# INNER WEST COUNCIL

## DEVELOPMENT ASSESSMENT REPORT

| <b>Application No.</b>                            | D/2018/132   |
| <b>Proposal</b>                                   | Alterations and additions to existing garage, including to provide a new first floor attic storage space.                    |

P-1803-A02

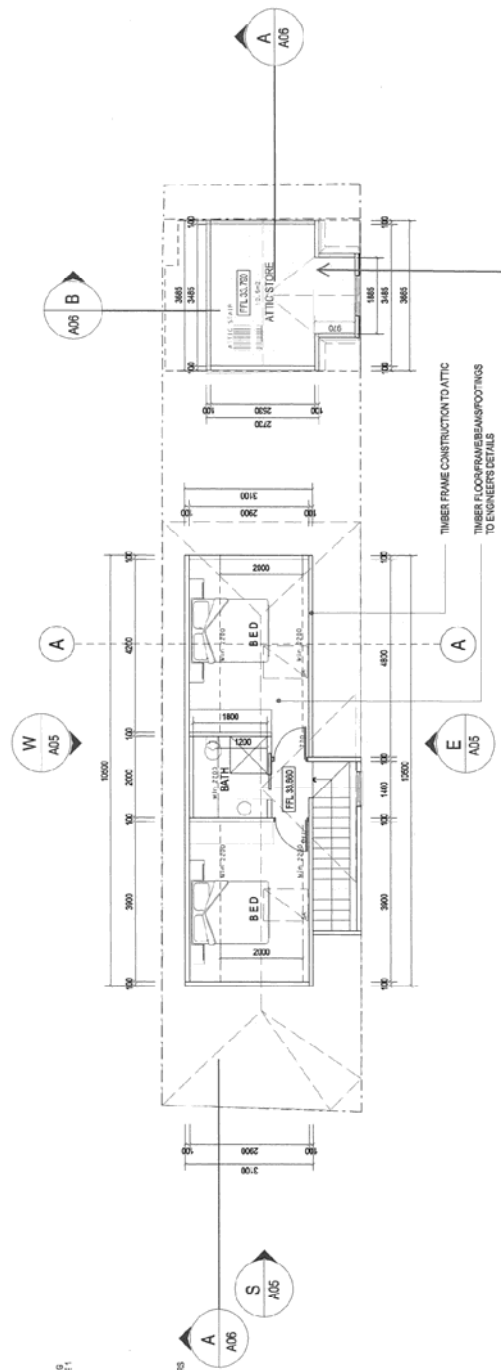
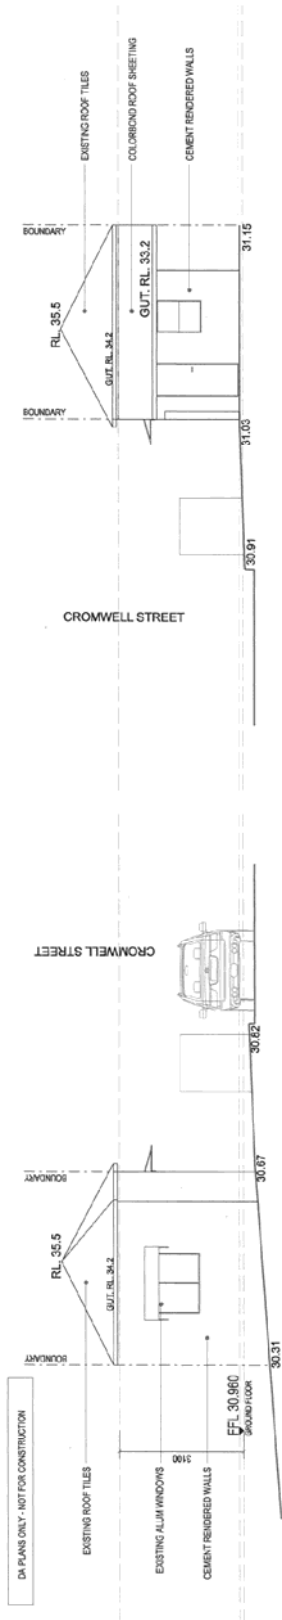
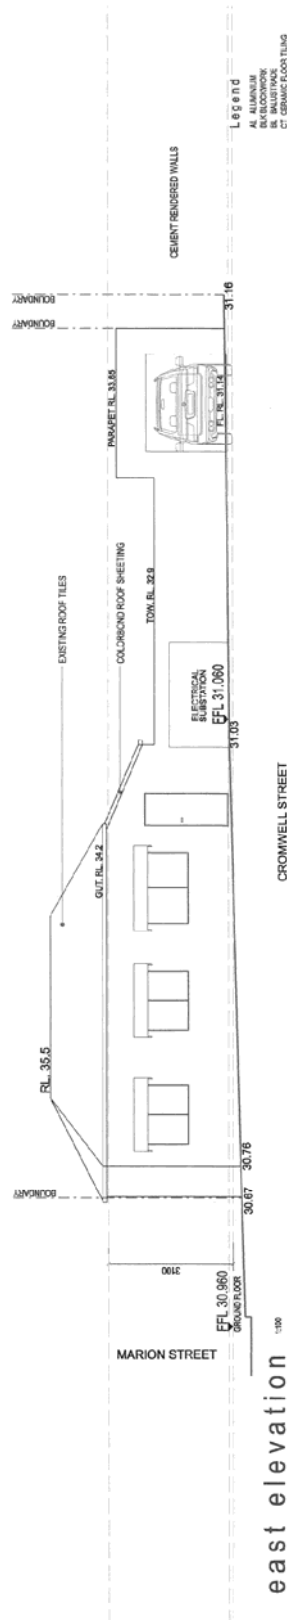
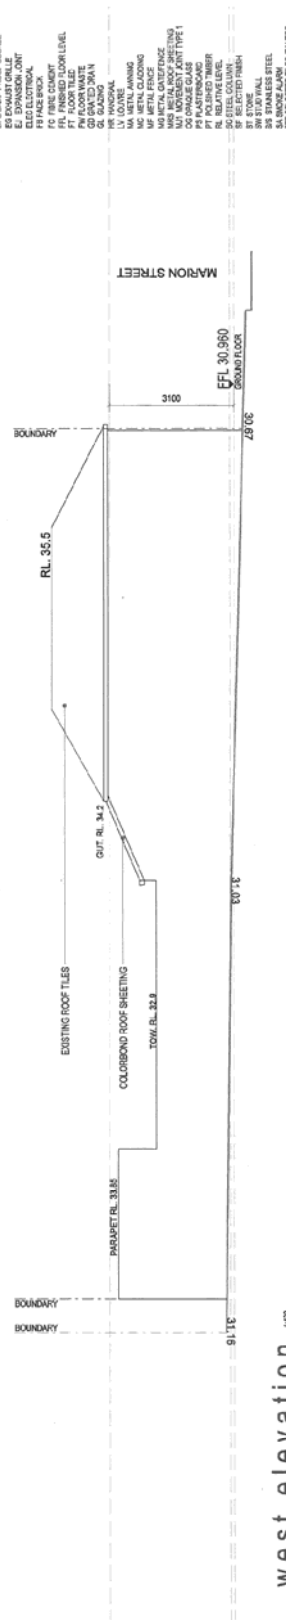
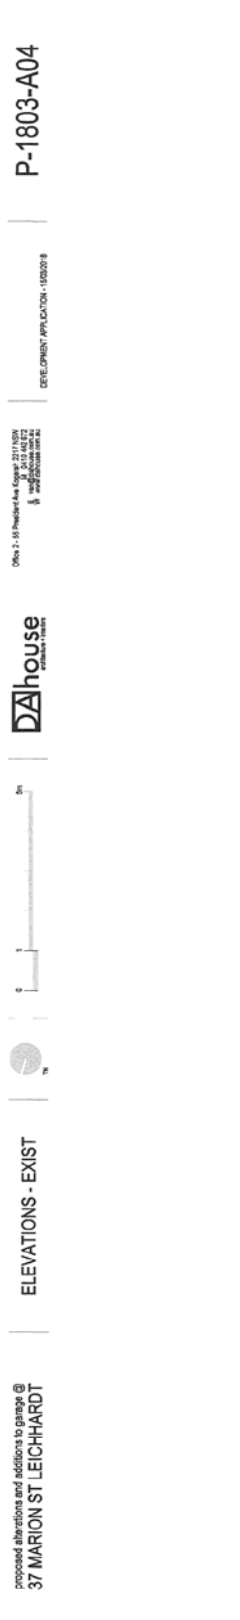
It is also noted that the submitted floor plans which indicate the widening of the existing garage roller door are not depicted or shown on the elevation plans submitted to Council. As such, the plans submitted are inconsistent.

shadow diagrams - june 21 - 10AM 1:20

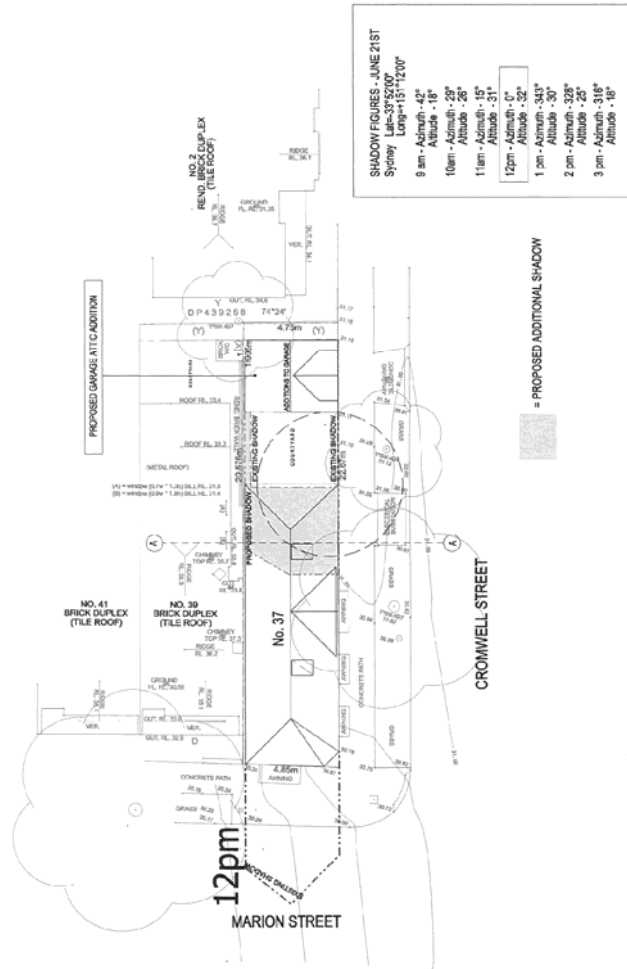
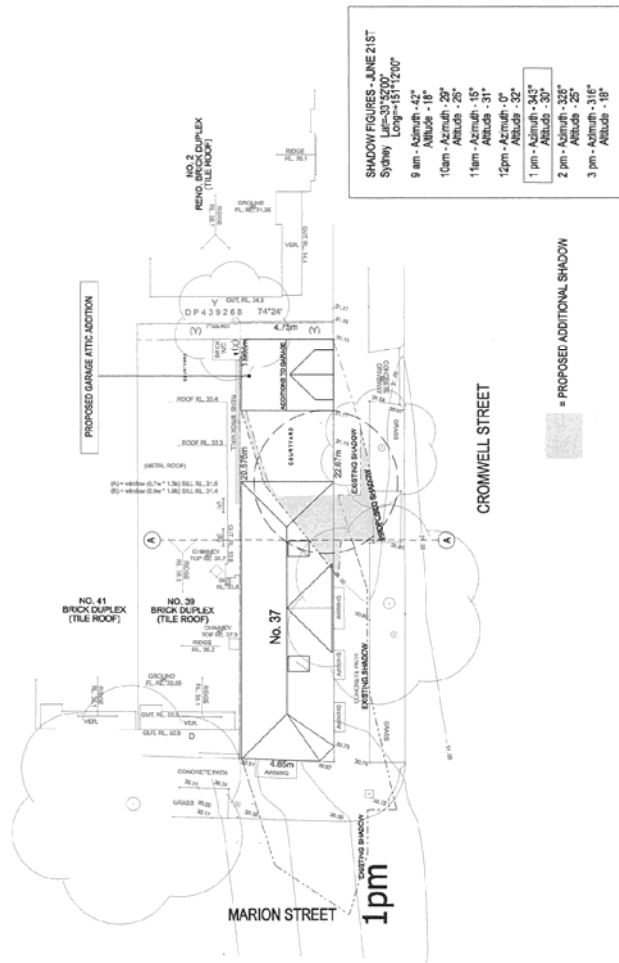
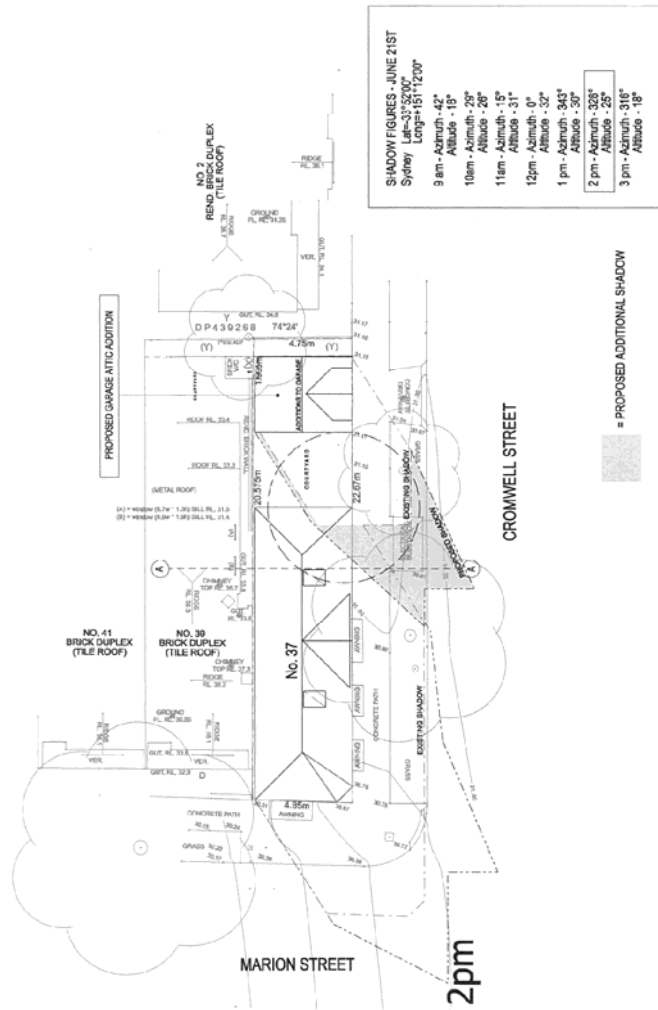
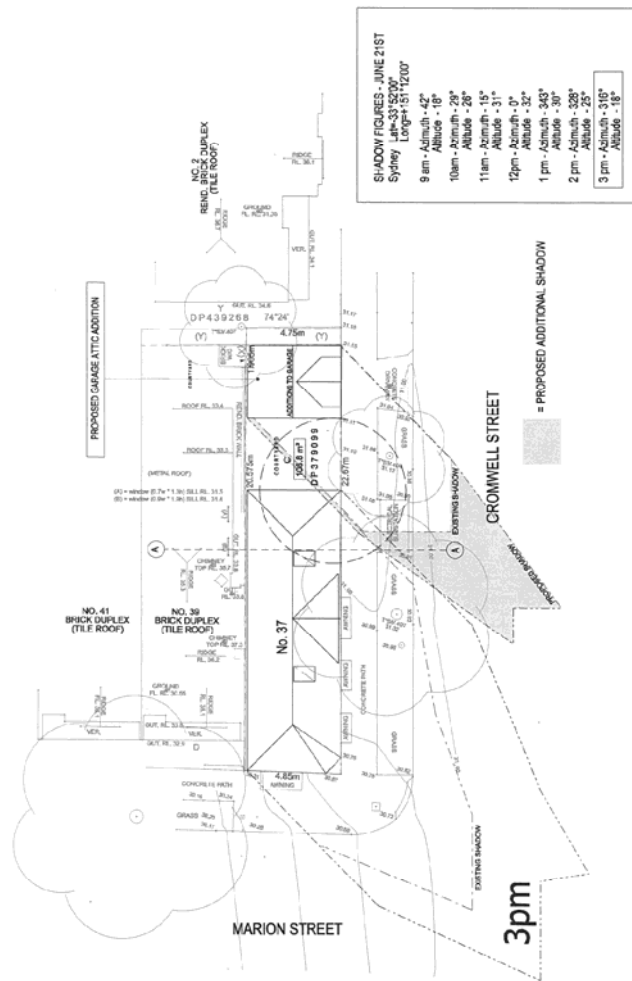
The proposed garage modification and the attic extension will not generate any new additional shadows at any time of the day during the winter solstice to the rear yard of No. 39 Marion Street, as depicted in the shadow diagrams submitted to Council. As such the proposal will comply with the above Controls relating to the neighboring properties private open space.
